# Access Compliance Report

### (Curb Ramps)

Intersection ID: 24827	Main Street: ARBORETUM_DR	Cross Street: PINEVILLE-MATTHEWS_RD	Location: W
ADA ID: 30246C6E69A8	Ramp Type: PerpDiag	Initial Pass/Fail: Fail	Overall Compliance: No
Severity Score: 35			
Codes/Mitigation Info/Possible Solution		Field Measurements/Component Compliance

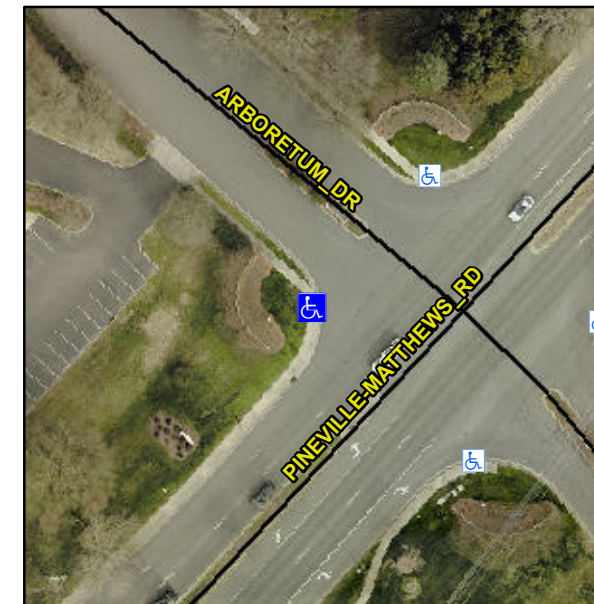
**R304.5.1, R304.2.2, R304.5.3**

Compliance	Description	Data	Compliance	Description	Data
N/A	Ramp Length (in)	59.0	No	Ramp Slope (%)	13.6
No	Ramp Width (in)	42.0	No	Ramp XSlope (%)	2.1
N/A	Flare Type LT	N/A	N/A	Flare Type RT	N/A
N/A	Flare Slope LT (%)	N/A	N/A	Flare Slope RT (%)	N/A
N/A	Flare Traversable LT?	N/A	N/A	Flare Traversable RT?	N/A
N/A	Landing Length (in)	N/A	N/A	DWS Provided?	N/A
N/A	Landing Width (in)	N/A	N/A	DWS Contrast?	N/A
N/A	Landing Slope (%)	N/A	N/A	DWS Length (in)	N/A
N/A	Landing X Slope (%)	N/A	N/A	DWS Full Width?	N/A
N/A	Landing Curb? (Y/N)	N/A	N/A	DWS Offset (in)	N/A
N/A	Shared Landing?	N/A			
N/A	Gutter Ponding?	N/A	N/A	Gutter Slope (%)	N/A
N/A	Gutter Lip Ht (in)	N/A	N/A	Gutter X Slope (%)	N/A
N/A	Painted X Walk1?	No	N/A	Painted X Walk2?	No
	X Walk 1 Direction	To SE		X Walk 2 Direction	To NE
N/A	X Walk 1 Width (in)	N/A	N/A	X Walk 2 Width (in)	N/A
	X Walk 1 Slope (%)	1.9		X Walk 2 Slope (%)	3.1
	X Walk 1 X Slope (%)	3.2		X Walk 2 X Slope (%)	0.2

**Remove & Replace Curb Ramp With Two New Directional Ramps or Equivalent.**
